TO: **COUNCIL ASSESSMENT PANEL**
 DATE: **28 OCTOBER 2020**
 SUBJECT: **COUNCIL ASSESSMENT REPORT**
 AUTHOR: **A STAMATOPOULOS**
DEVELOPMENT OFFICER - PLANNING

DA NO.	:	<u>110/00528/20</u>
APPLICANT	:	<u>DOMAIN BUILDING GROUP</u>
LOCATION	:	<u>8 HAMILTON STREET, GLENELG NORTH</u>
DEVELOPMENT PLAN	:	<u>CONSOLIDATED 2 JUNE 2016</u>
ZONE AND POLICY AREA	:	<u>RESIDENTIAL ZONE</u>
NATURE OF DEVELOPMENT:		<u>MERIT</u>
PROPOSAL	:	<u>TWO, TWO STOREY SEMI-DETACHED DWELLINGS WITH ASSOCIATED SWIMMING POOLS</u>
REFERRALS	:	<u>NIL</u>
CATEGORY	:	<u>ONE</u>
REPRESENTATIONS	:	<u>NOT APPLICABLE</u>
RECOMMENDATION	:	<u>DEVELOPMENT PLAN CONSENT SUBJECT TO CONDITIONS</u>

Two Semi-Detached Two-Storey Dwellings
at 8 Hamilton St., Glenelg North
for A Shtjefni

Above: 2 Hamilton Street Glenelg North
Below: 1 Hamilton Street Glenelg North

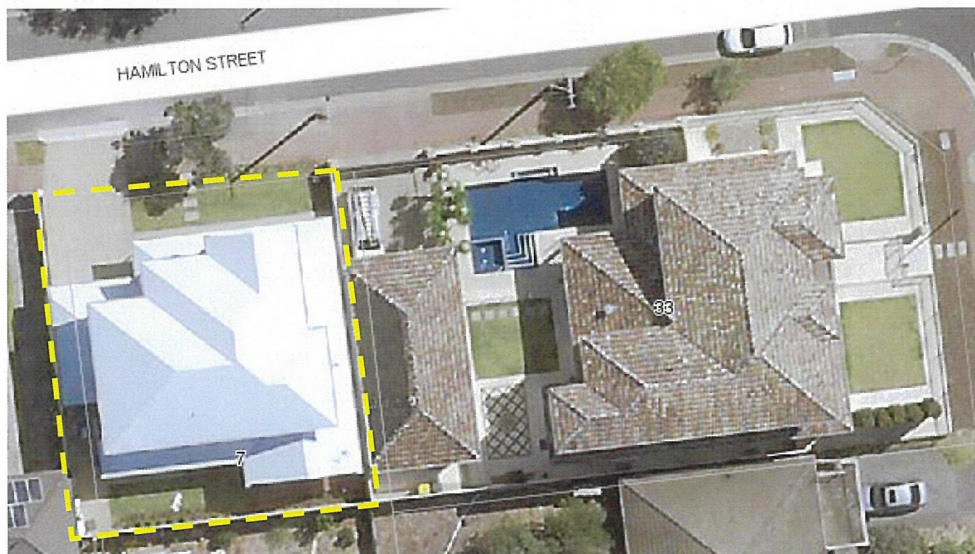
The streetscape of Hamilton Street contains inconsistent dwelling styles and varied setbacks both on the northern and southern side. There are two examples of carports located forward of dwellings at 1 and 2 Hamilton Street where both are in close proximity to the primary boundaries of their respective allotments.

Site Plan
 DBG200420-P1C
 Scale at A3 1 : 200
 Drawn by LDB
 For Planning Approval

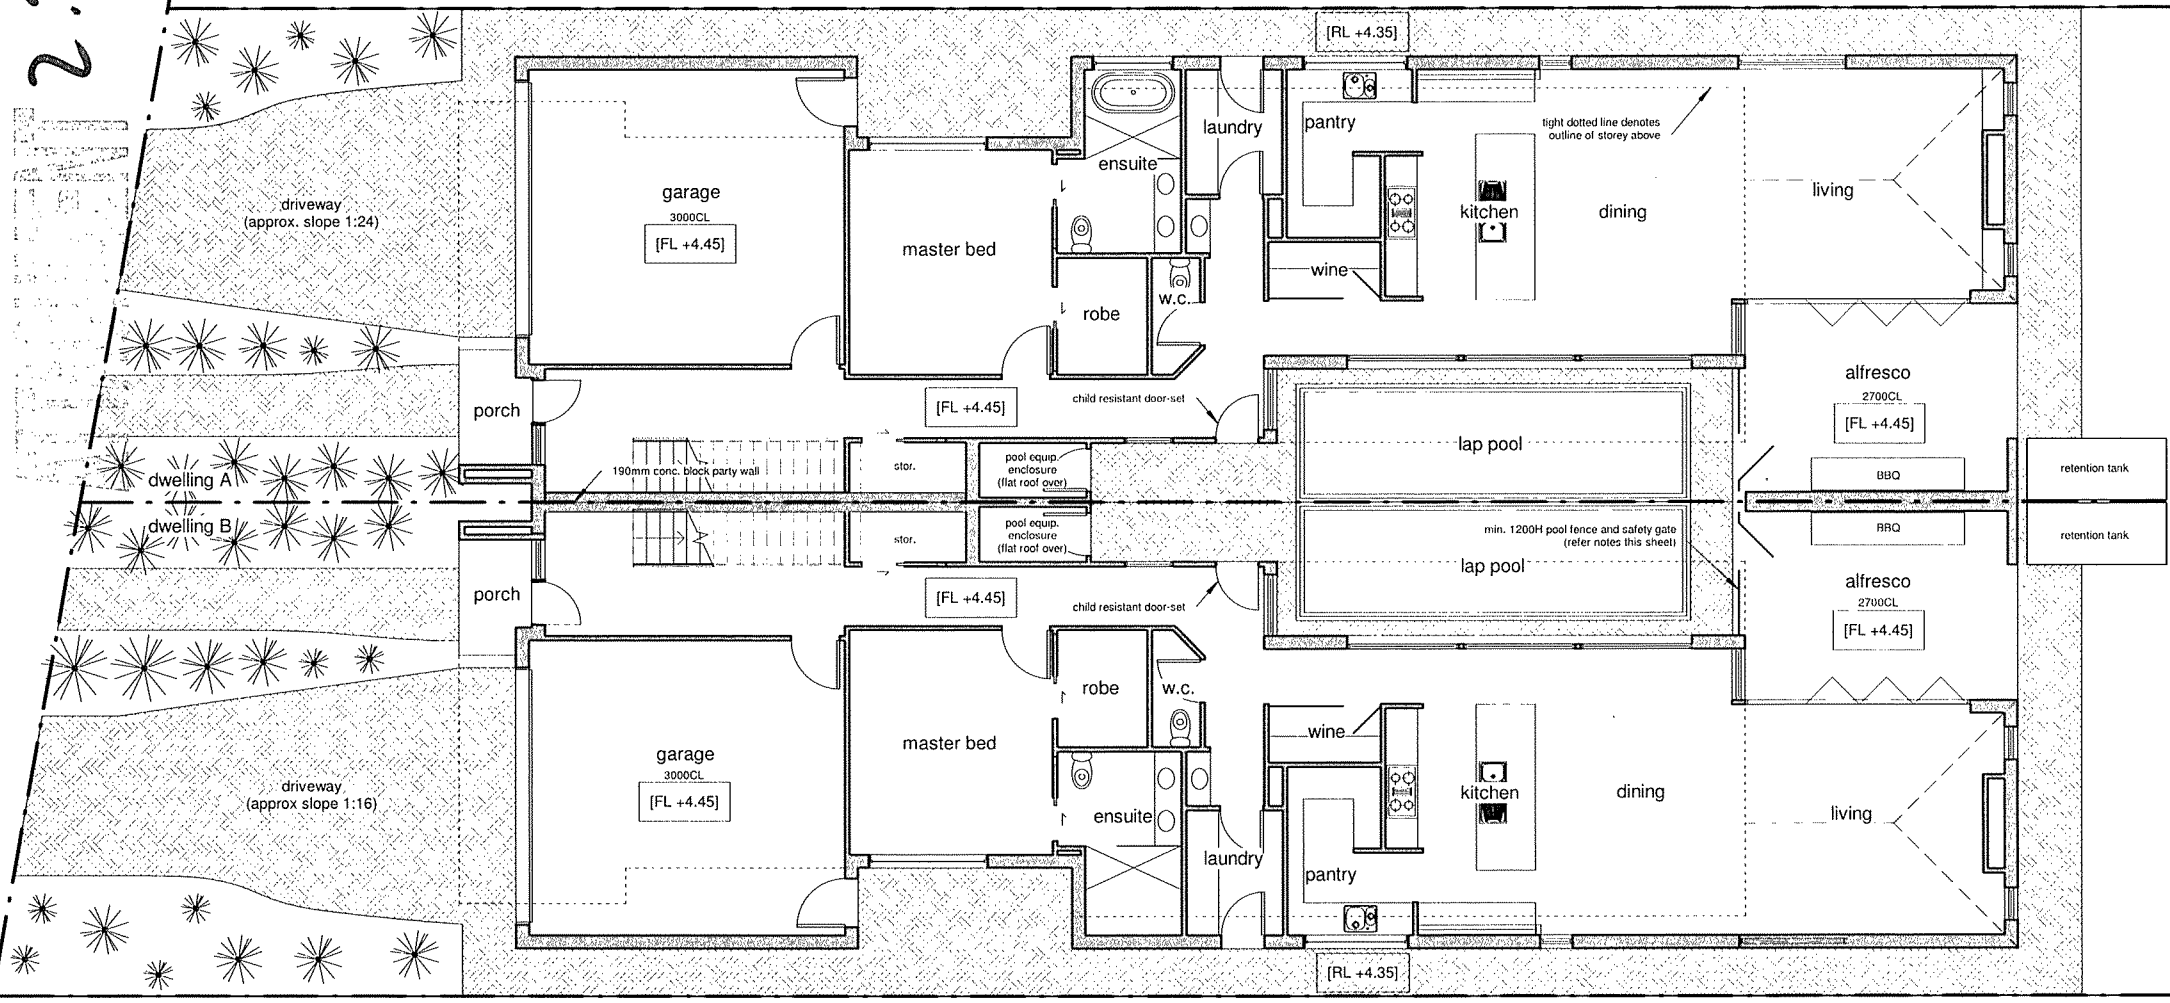
A shortfall in the primary setbacks of the proposed dwellings were noted during the quantitative assessment of the application. PDC 19 of the General Section Residential Development anticipates dwellings to contain the same setback as the adjacent buildings with a frontage to the same primary street. The property to the east is located on the corner of Hamilton Street and Patawalonga Frontage where its primary frontage is toward Patawalonga Frontage and not Hamilton Street. As this is the case, to satisfy PDC 19, the primary setback of 6 Hamilton Street which adjoins the subject site to the west is there reference point to determine the primary setbacks.

6 Hamilton Street contains a varied primary setback of 8.2m to 10.8m due to the angled nature of the front boundary. The proposal contains setbacks varying from 5.7m to 8.2m for dwelling A and 7.7m to 9.1 for dwelling B, therefore not complying with PDC 19.

While it is noted that from a quantitative perspective the primary setbacks of the dwelling do not comply with the development plan, there is merit for the proposed setbacks when assessed in context with the immediate locality.

As sites like the proposed become divided it is fair to anticipate that primary setbacks of dwellings will be lesser than those of existing original allotments where a much larger area is available to accommodate built form. Notwithstanding, the proposed setbacks are considered to be substantial for the site particularly where a two storey dwelling across from the site has been approved with setbacks of 3.9m and 6.2m albeit on an allotment with lesser depth.

Line Of Sight Diagram

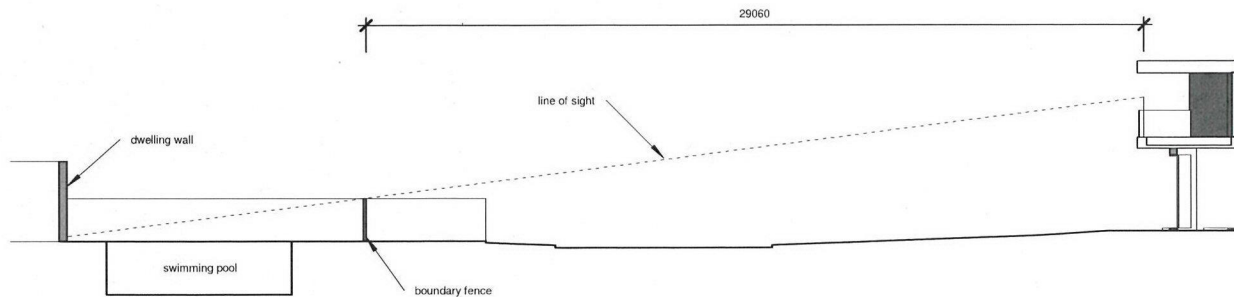
Concerns were raised regarding the front balconies and their potential to overlook the private open space of 33 Patawalonga Frontage. The aerial below shows the subject site and its proximity to 33 Patawalonga Frontage.

PDC 41 makes it clear that screening should be implemented on balconies that are *adjoining* the site of the development. However, PDC 40 states that balconies that overlook private open of dwellings should implement screening devices with no mention as to whether this applies to directly adjoining properties. In the circumstances of the application it is considered that there is potential for a loss of visual privacy to the private open space of 33 Patawalonga frontage.

Concerns of overlooking were raised with the applicant who provided a line of sight diagram showing views from the front balconies. The diagram shows that views into the private open space of 33 Patawalonga Frontage will be slightly screened by the boundary fence however views into the alfresco area and back yard will remain in view.

Due to the contradiction of Council policy regarding visual privacy, the requirement for screening needs to be balanced with the potential outlook from the balconies. There is scope for regard to be given to the policies of the Residential Code regarding front facing balconies and their relationship to dwellings on adjacent land. It must be noted that the subject site is not located in a gazetted area for Residential Code assessment however to provide context for the situation a discussion could prove to be beneficial.

A potential solution is to place a condition on the assessment which can then be reviewed during construction in order to assess impacts of overlooking if the Council Assessment Panel determines that screening devices should be implemented to the front balconies.
